Melton City Council Submission

Melton East Precinct Structure Plan and Infrastructure
Contributions Plan

Melton City Council

April 2025

Figure 7 | Arterial Roads | Bus Rapid Transit

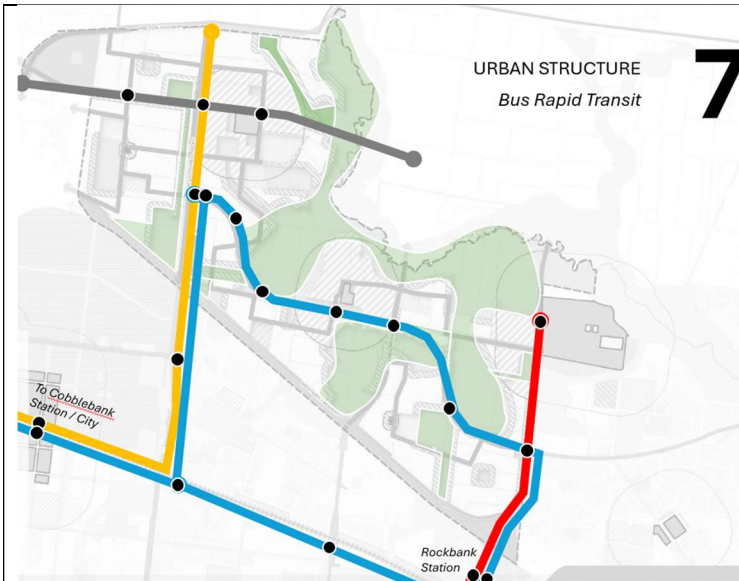
- Provide resilient and sustainable mobility from day one
- Revise section to include **dedicated** Bus Rapid Transport Lane (BRT)
- BRT to create a continuous loop around the precinct, alongside the arterial road network to deprioritize car dependency and allow access to the Cobblebank City Centre, Hospital, Schools and two train stations.
- The plan could begin with immediate, low-cost BRT implementation on arterial roads using temporary methods such as paint and plastic barriers.
- Over time, more significant improvements can be made to the BRT system's infrastructure.

Figure 8 | Arterial Road Section

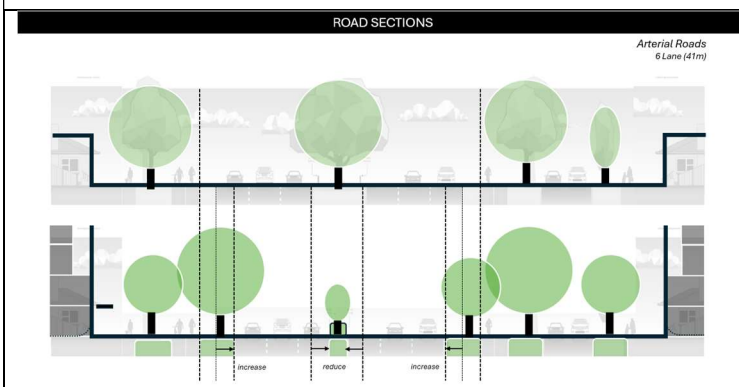
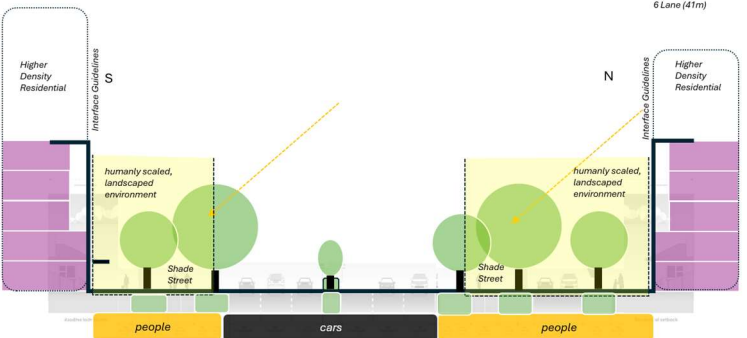
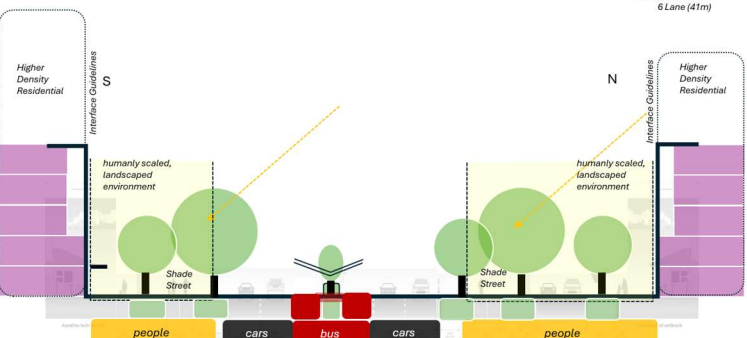
- Consider a more human centred, humanly scaled approach to the Arterial Road section.
- Reduce centre median from 6m to 2m as it will never be accessible or used by people
- Add 2m on each side of the shared paths to create a barrier between people and cars.
- This would provide a shade street effect whereas previously no protection was provided to the shared path network.

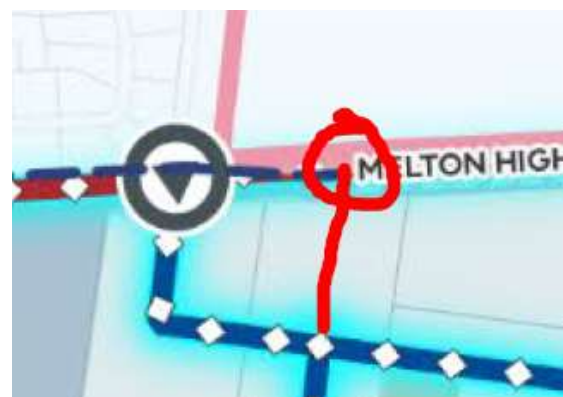
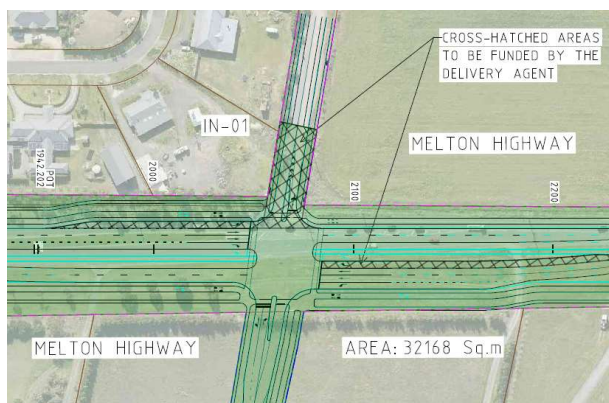
IN-01 - Southern leg should be changed so it is offset from Ryans Lane and Ryans Lane should be a left-in left-out treatment. There is no need to show further scope to be delivered by others.

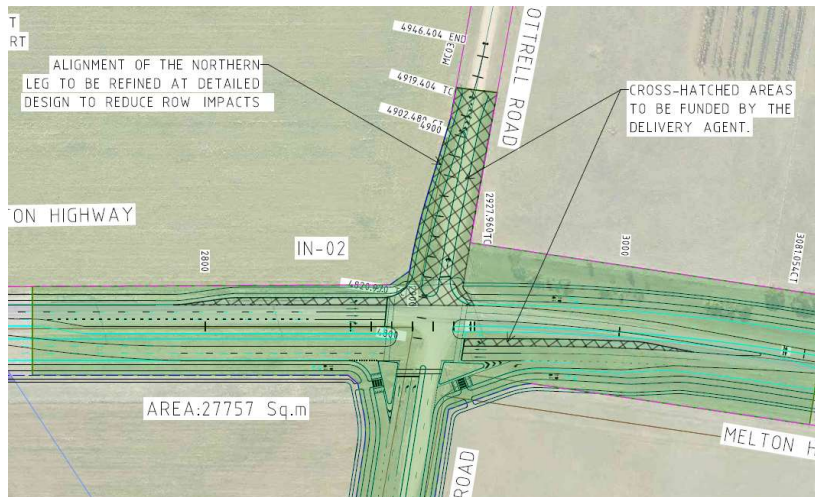
IN-02 – Council does not support the northern leg not being captured in scope. How would existing residents and businesses such as the plant nursery to the north use this intersection safely?

The western leg should have 2 right turn lanes in the ultimate arrangement as per other arterial-arterial turning movements (refer to Plumpton PSP Hopkins Road/ Melton Highway intersection).

The interim and ultimate kerbs up to the extent of the left turn lane on the eastern leg should match to avoid redundant works being shifted right at the intersection.

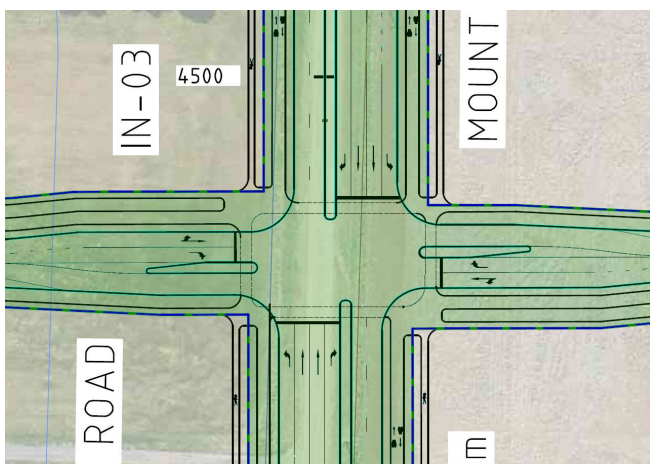
IN-03 - The separated footpath and bike path treatment flips from the northern side on the west leg to the southern side on the east leg. This drawing should be amended to allow for continuous for east-west travel and avoid crossing the road. It is noted there are open space and community facilities on the southern side so this is the preferred side to have this treatment.

Separated paths should be on the southern side of the connector roads.

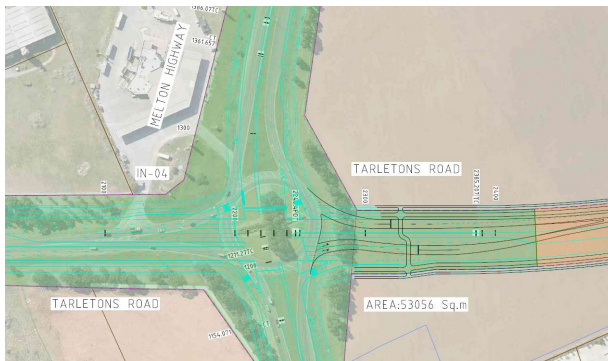
IN-04 – The roundabout with pedestrian signals on eastern leg is not supported. Council requests that this should be changed to be a fully signalised intersection to improve safety and efficiency for all legs and modes of transport.

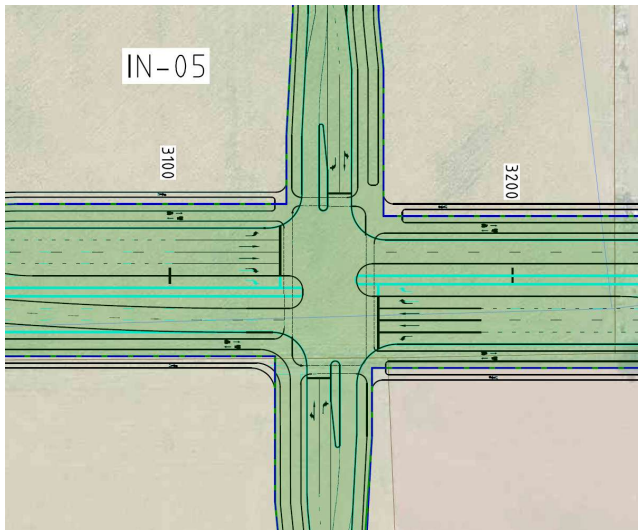
IN-05 - Separated paths should be on the western side of the connector roads.

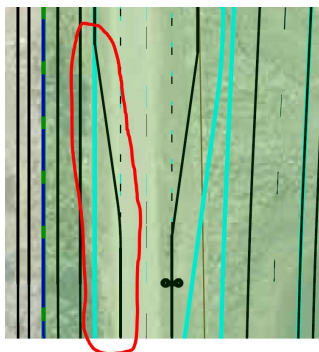
IN-06 - The western carriageway on the southern leg seems to have significant redundant kerb lines between interim and ultimate arrangement. Council submits that the interim and ultimate kerbs on the western side are consistent to avoid removing kerbs in future.

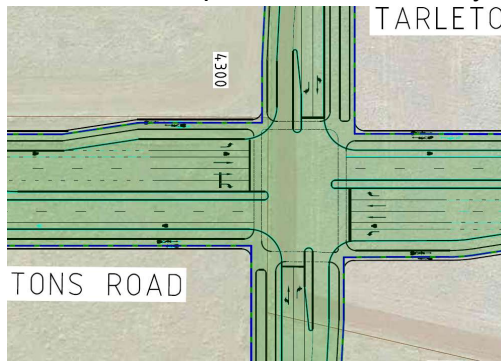
IN-07 – Council submits that the separated paths should be on the eastern side of connector roads. Council questions why are on-road bike lanes and shared paths provided here instead of the off-road separated footpath and bike path treatment?

Left turns on Tarletons Road seem short. To be reviewed with updated VPA transport assessment report and SIDRA analysis.

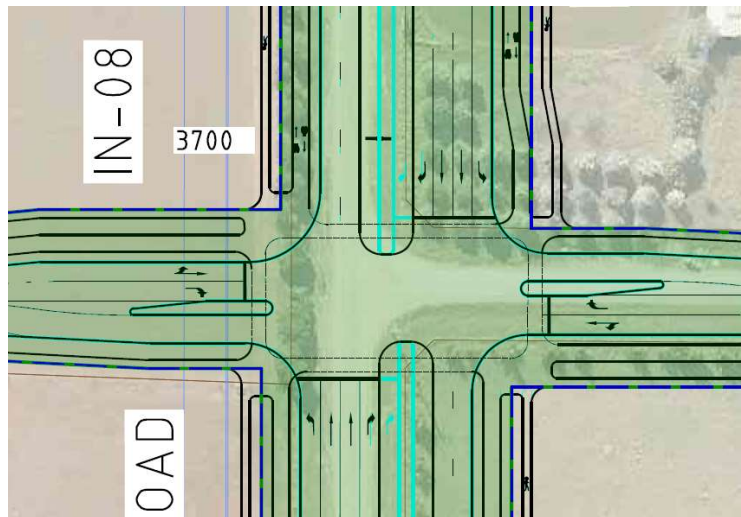
IN-08 – Change the separated paths to be on the southern side of the connector roads.

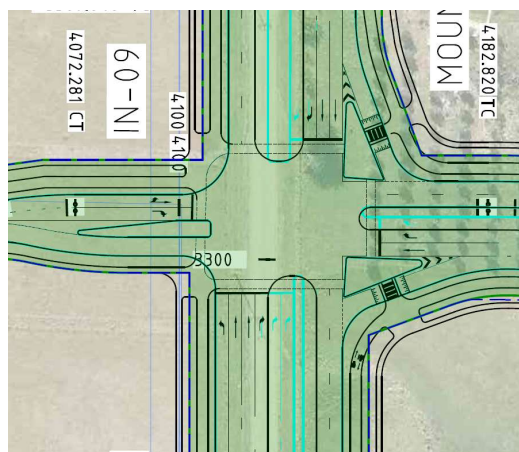
IN-09 – Change the separated paths to be on the southern side of the connector road.

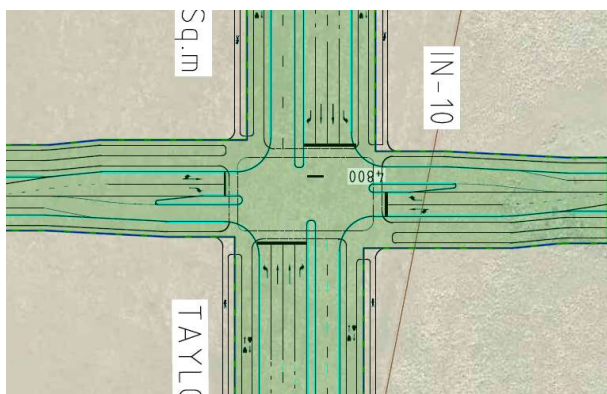
IN-10 - Change the separated paths to be on the southern side of the connector road.

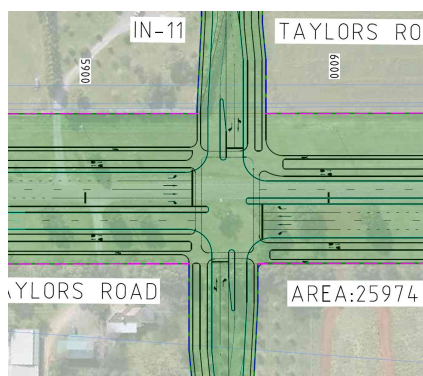
IN-11 - separated paths should be on the east side of the connector roads.

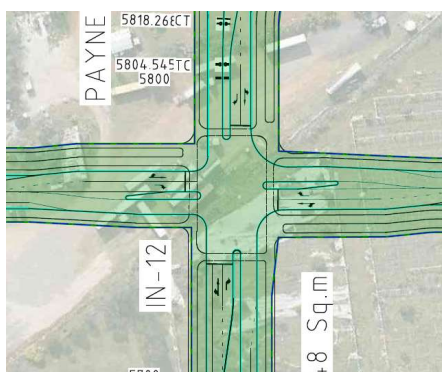
The on-road bike lanes are not adequately connected through the intersection and to shared paths when they start and end. Council preference is for separated footpaths and bike paths rather than shared paths and on-road bike lanes.

Right turn lanes look too short for adequate vehicle storage on Paynes Road both legs.

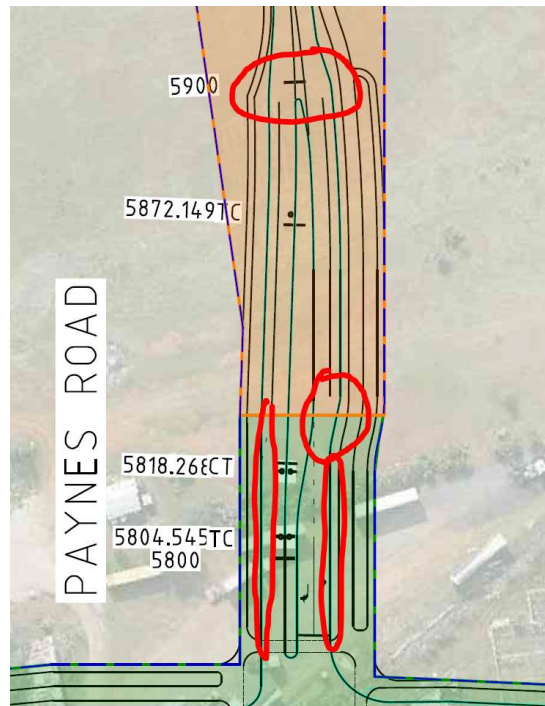
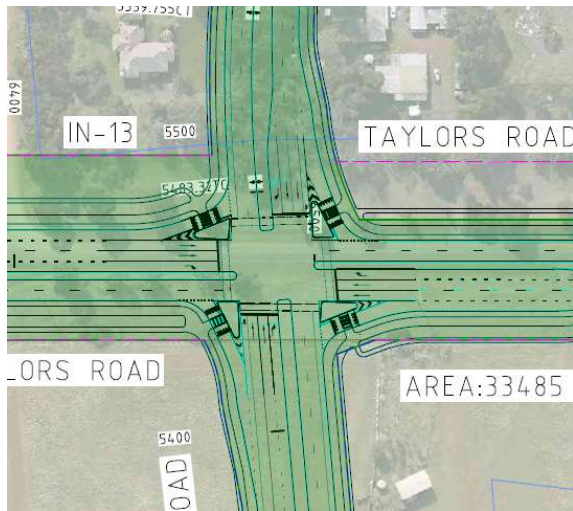
IN-13 - right turn lane from Paynes Road north to Taylors Road looks too short

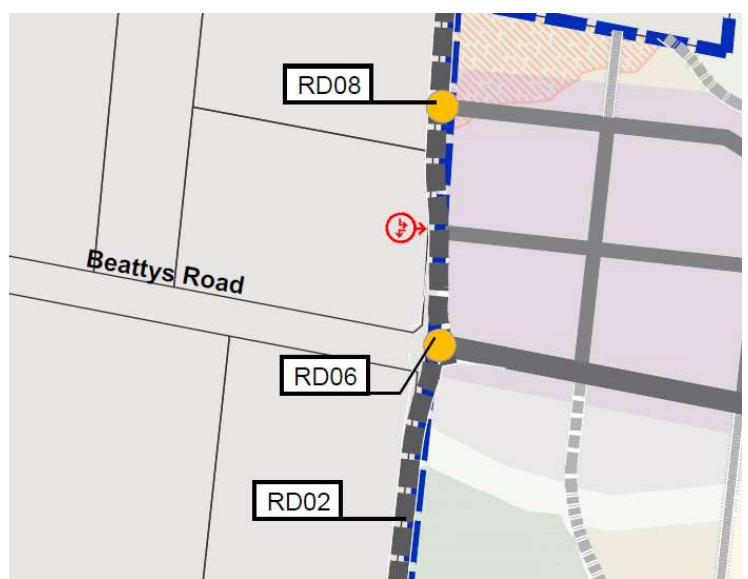
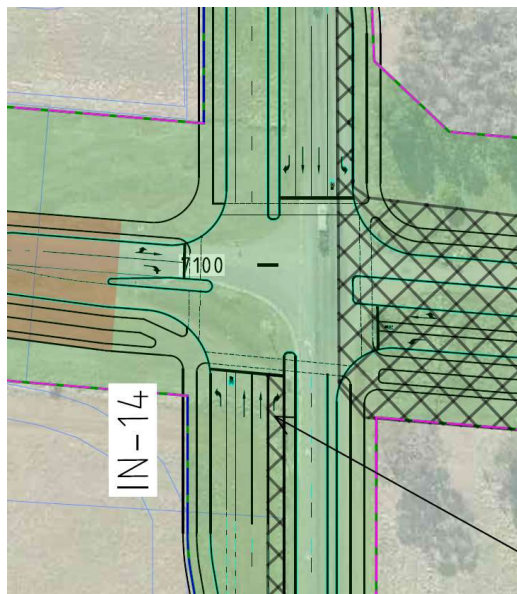
Council does not support the eastern leg and turn lanes being excluded from this ICP and identified as "funded by delivery agent". Note this is signalised intersection RD-06 in Rockbank North PSP and this ICP should add the remaining scope required.

The western leg should be designed in a way that maximises the landscaping/ open space in Beattys Road corridor by pushing it to the northern or southern extent of the road reserve, not separate into two smaller landscaped areas

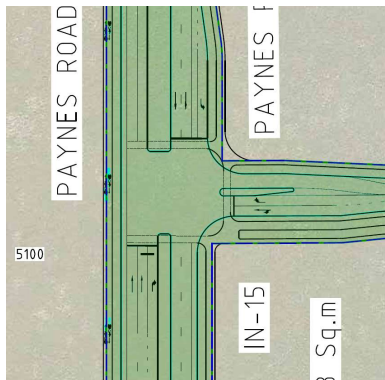
IN-15 – Council submits that separated paths should be on the northern side of connector road. There should be no straight arrow for the eastern leg Left turn lane from northern leg to eastern leg seems very short.

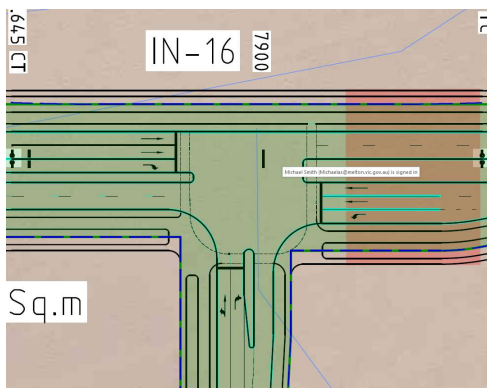
IN-16 – Council submits that there should be no straight arrow for the southern leg.

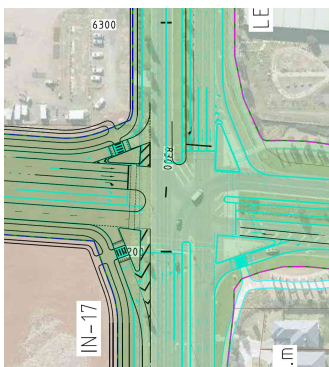
There are currently on-road bike lanes on the eastern leg of Taylors Road and both sides of Leakes Road. This intersection should include the logical tie-ins from bike lanes to the path network where they are not continuing.

The interim arrangement should allow for two right-turn lanes from Taylors Road west leg onto Leakes Road due to high demand to access the Western Highway.

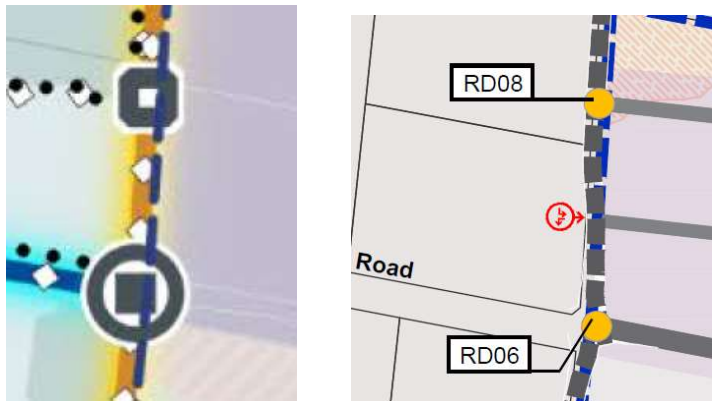
Council submits that pedestrian signals on Leakes Road north of Beattys road should be shown as a signalised T-intersection as per the Rockbank North PSP RD-08.

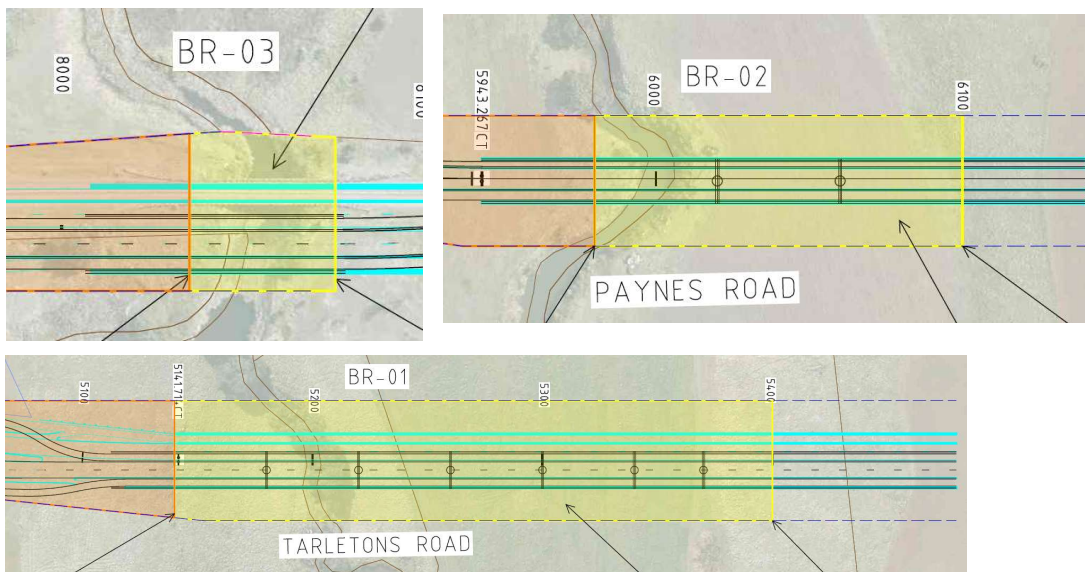
Council submits that the road extents extend beyond bridge infrastructure which isn't feasible to build without the bridge itself. Bridge project extents should capture the full extent of barriers and/ or batters of the bridges.

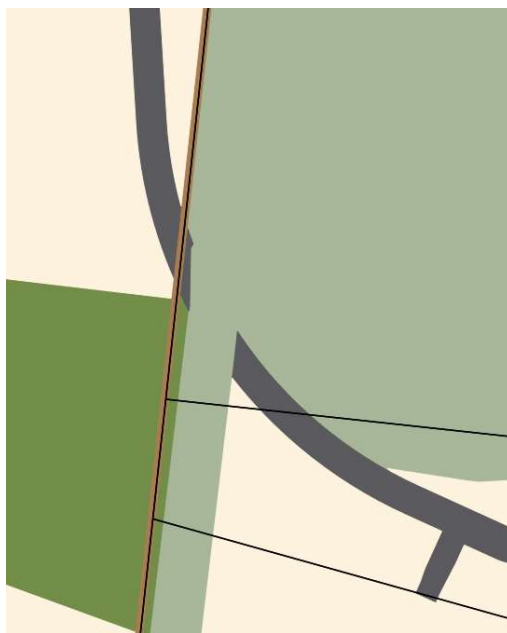
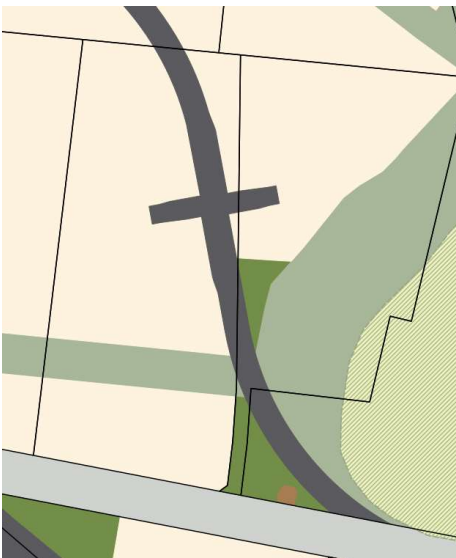
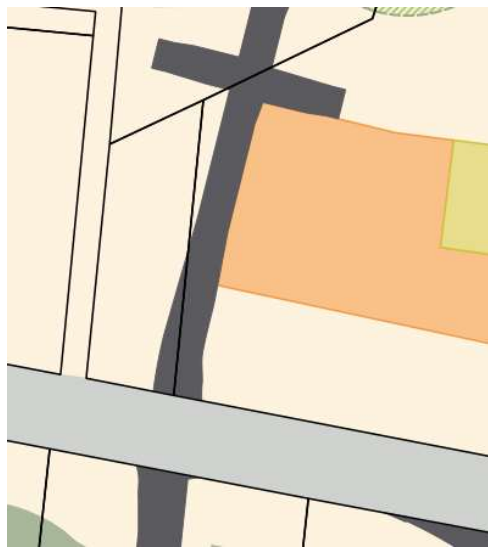
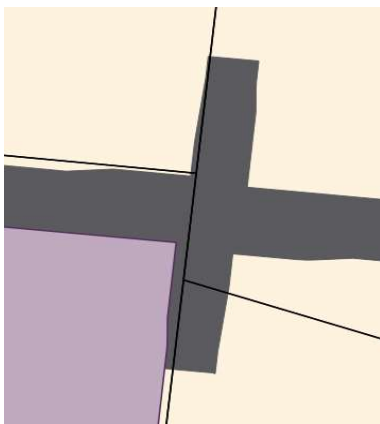
Council submits that road alignments should be changes to minimise the number of properties required to complete the road/ intersection and should avoid creating undevelopable segments of land.

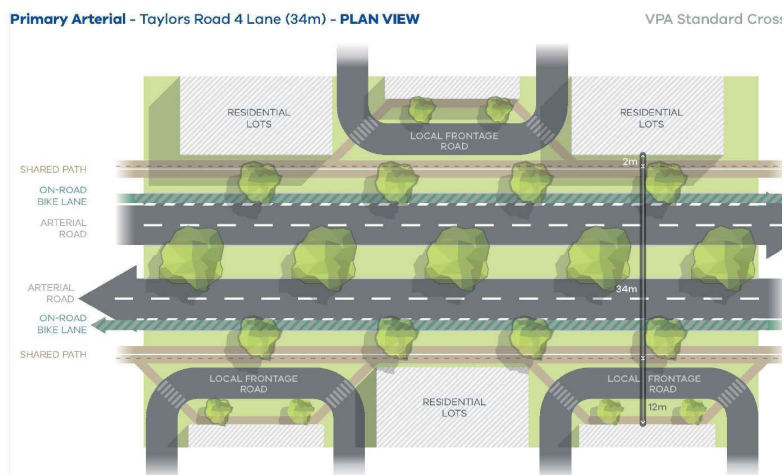
Council submits that the dog-leg connector road intersections with a pedestrian signal at the school precinct in close proximity to open space and activity centre is not supported and should be changed. This needs to be a consolidated cross intersection, either identified as a signalised intersection or a roundabout with raised priority crossings to improve safety in an area that will have high volumes of vehicles, pedestrians and cyclists

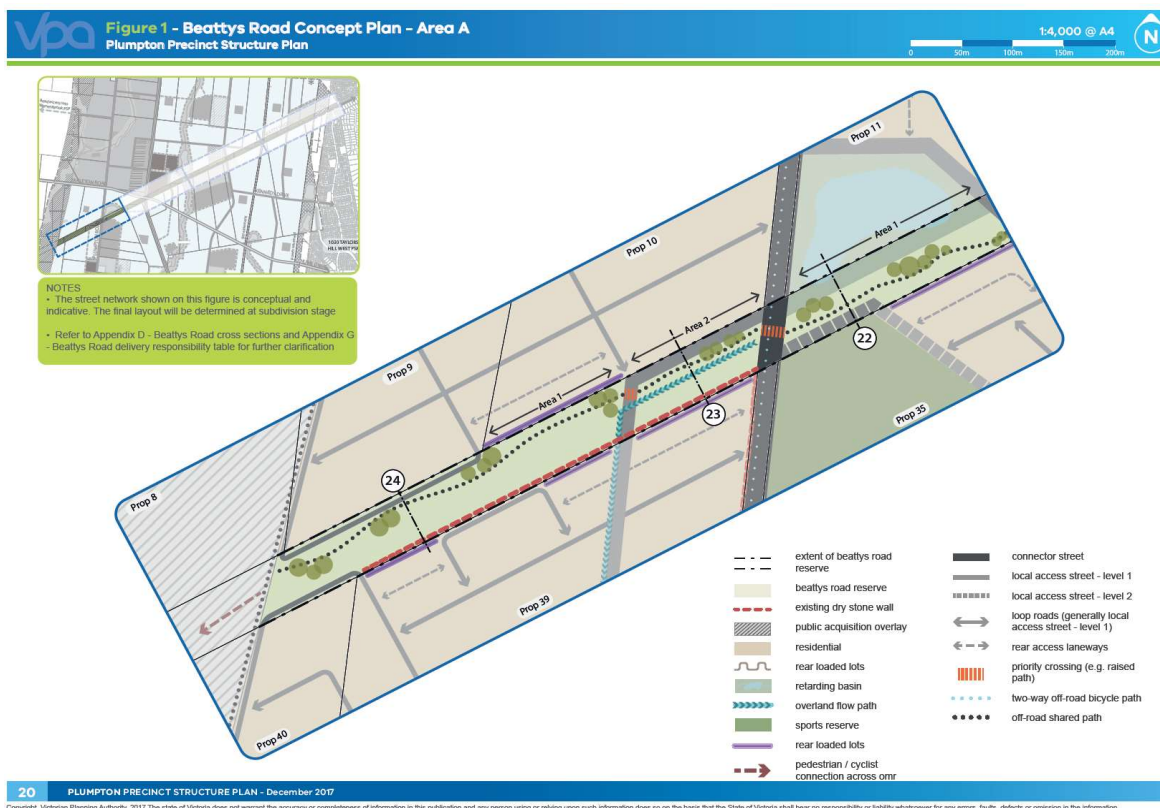
The Plumpton PSP shows concepts for the Beattys Road corridor to show how the large road reserve should be used. Council request that the PSP be changed to include this concept also.
